Tłıchǫ All-Season Road

GNWT Technical Report Responses to Wek'èezhì Renewable Resources Board Boreal Caribou

**Prepared for the Mackenzie Valley
Environmental Impact Review Board EA1617-01**

1 November 2017

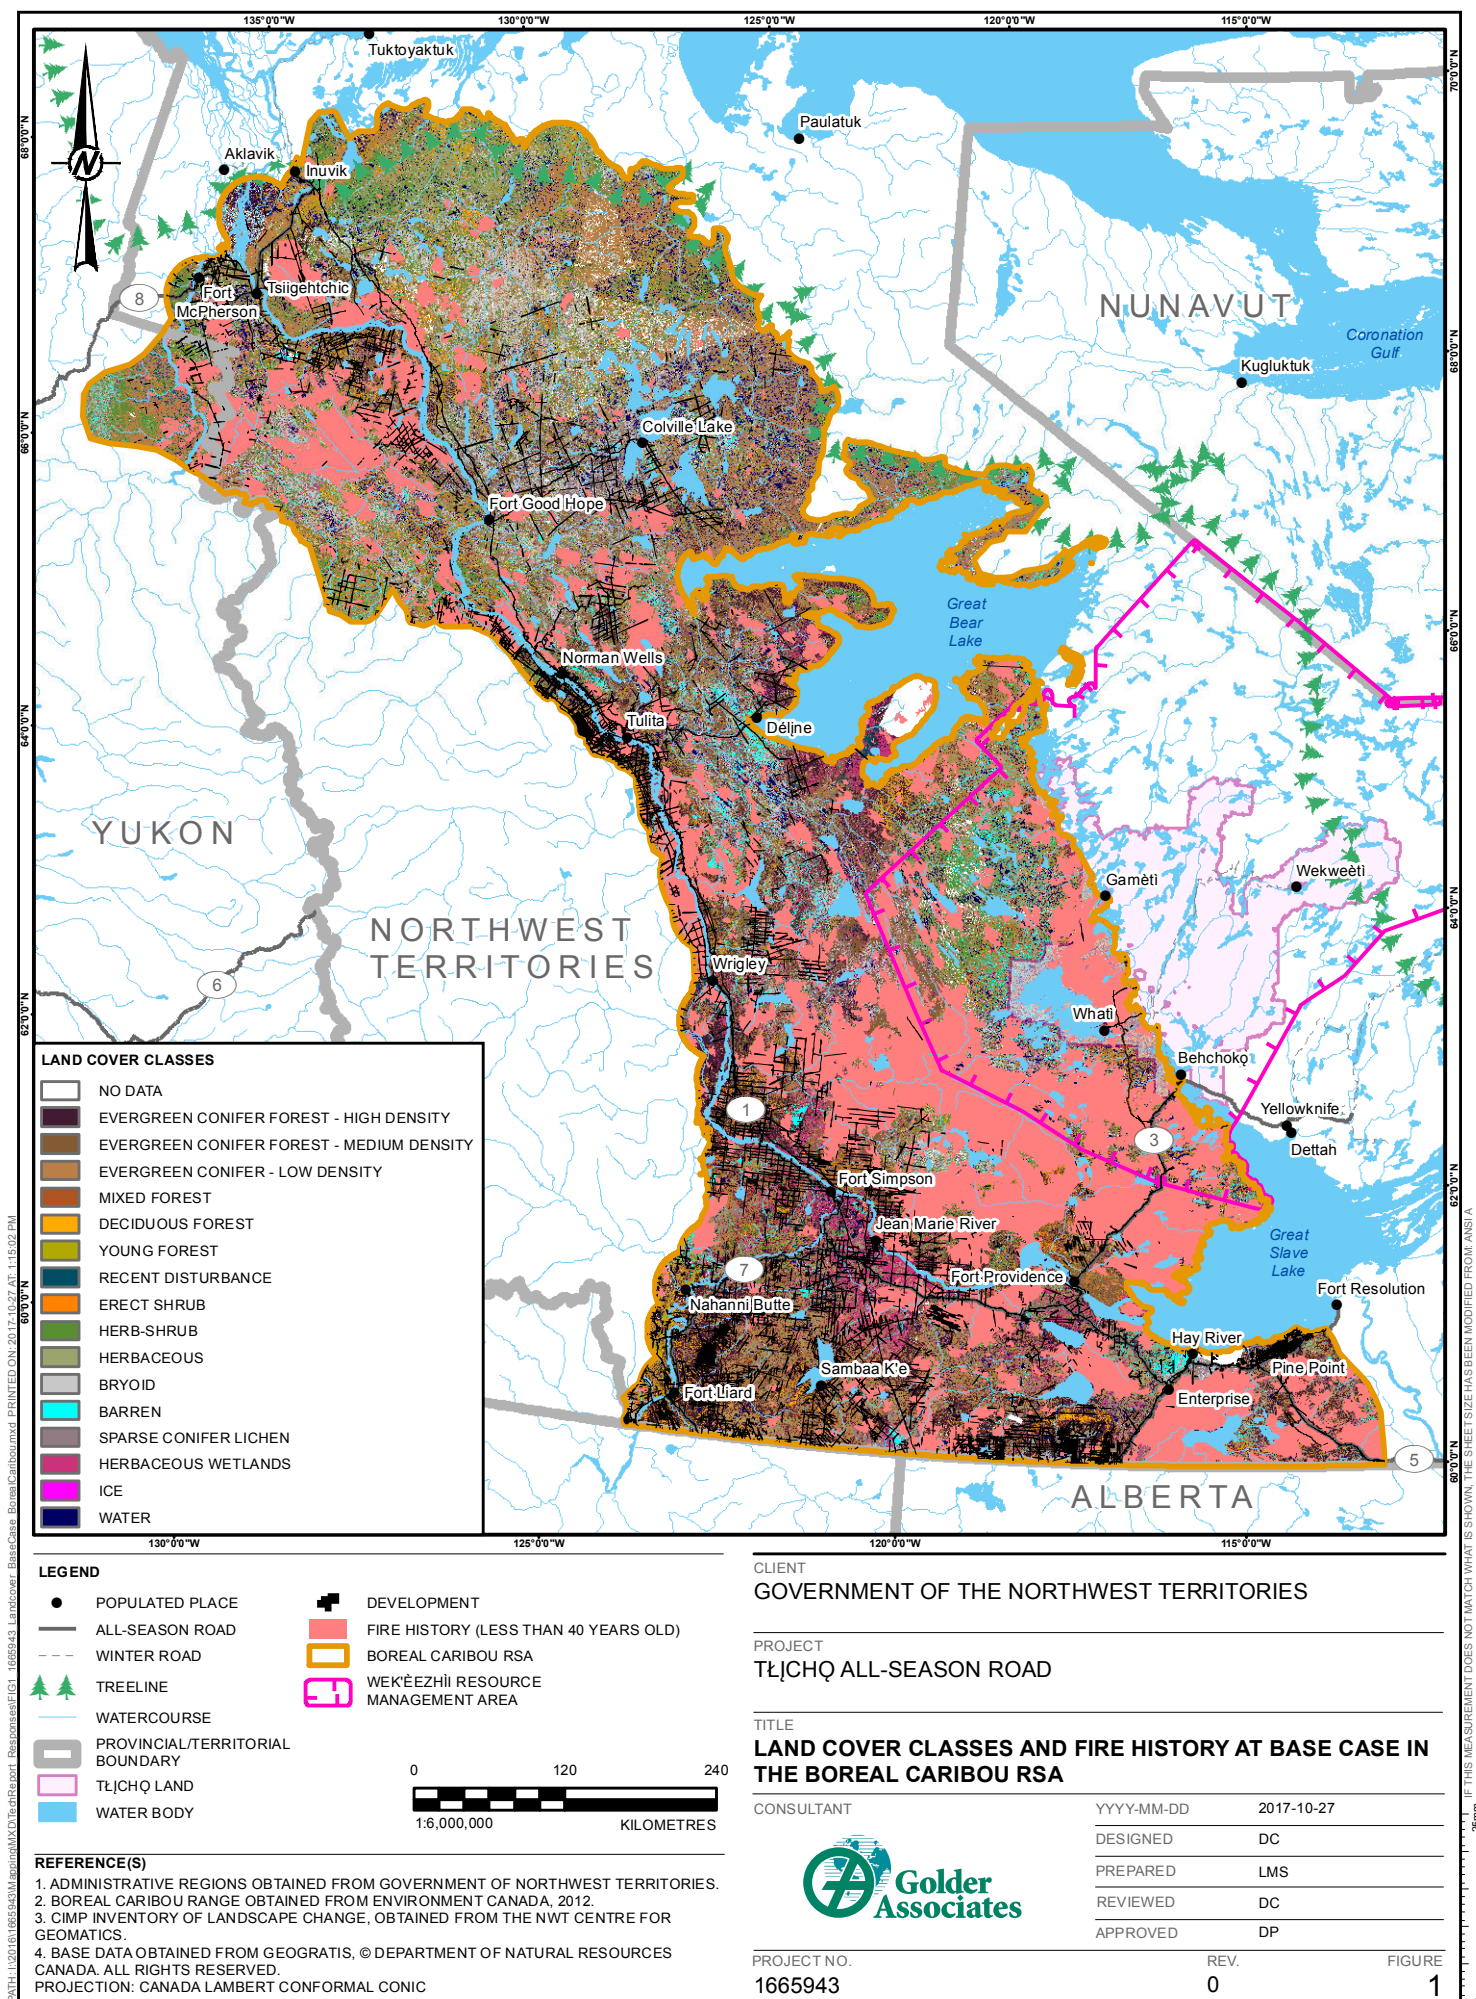
The WRRB recommends that the Base Case be revised to include updated and additional information, specifically:

- a) Analyses of habitat including reporting on habitat availability and distribution relative to biophysical attributes; and,
- b) A complete account of the range of natural variation in the survival and reproduction information as well as a more complete account of harvest levels using Tłıchǫ knowledge

As noted in ASR Section 4.2.2, Landsat SPOT 4/5 (SPOT) imagery data (Olthof et al. 2015) was used to delineate the abundance and distribution of biophysical attributes of boreal caribou at the Base Case and was also used as the base habitat layer for all wildlife valued components. Fire and development data through 2016 were intersected with the imagery to described the existing environment (Base Case). The area summaries of the SPOT imagery land covers at Base Case for the NT1 Range are provided in Table 1. For illustrative purpose the land cover areas at the Project Case are also provided in Table 1. The associated distribution of these land covers at the Base Case is provided in Figure 1.
